SUBJECT: HEATER DUCT/CLAMP INSTALLATION

MODELS AFFECTED: Mooney Models M-20C S/N: 690001 thru 690098
700001 thru 700076
M-20G S/N: 690001 thru 690020
700001 thru 700006

SIDE VIEW LOOKING INBD. FROM R.H. SIDE

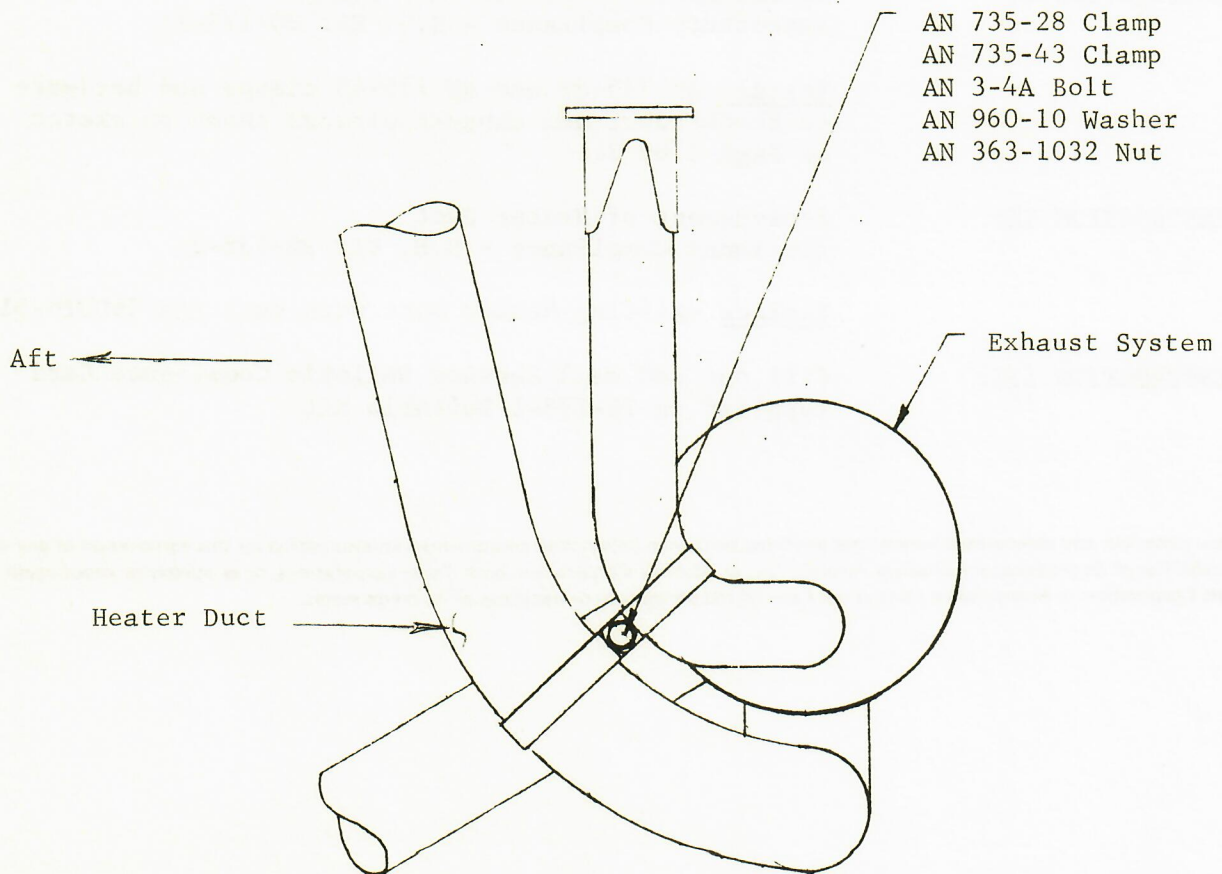
INTRODUCTION: Reports have been received of the heater duct contacting the right rear exhaust pipe resulting in deterioration of the duct. To preclude this condition accomplish the following instructions.

INSTRUCTION I: Installation of Heater Duct Clamp
(Mandatory Compliance - S.B. Kit 20-178-1)
Install AN 735-28 and AN 735-43 clamps and hardware on heater duct and exhaust pipe as shown on sketch on Page 2 of 2.
